## **R44**

## **SERVICE BULLETIN SB-56**

**SUBJECT:** Seat Belt Buckle Assemblies

**BUCKLE INSTALLATION**

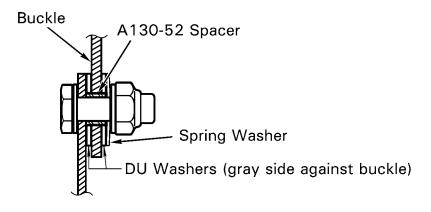
**BACKGROUND:** Leaning on or sliding across seat belt buckles can bend and damage their stainless support straps. RHC has received reports of damaged straps cracking in service. C628-4 revision N buckle assemblies are designed to prevent cracking.

- 1. Refer to figure on page 2. If helicopter is equipped with revision M or prior buckle assemblies, complete steps 2 and 3 within compliance times noted above.
- 2. To inspect, cut and remove plastic covers from all four C628-4 buckle assemblies. Visually inspect buckle assembly stainless straps, particularly in the vicinity of rivets. Replace any buckle assemblies with cracked straps before further flight.

- 3. To replace, order one C628-4 buckle assembly and one A130-52 spacer for each affected seat. Remove bolt at base of buckle assembly noting hardware stack-up. (See figure on page 2.) Install revision N or later buckle assembly using same hardware except replace A130-52 spacer with new spacer. (New spacer is slightly longer to reduce friction in joint.) Torque to 120 in.-lb.
- 4. Make appropriate maintenance record entries.
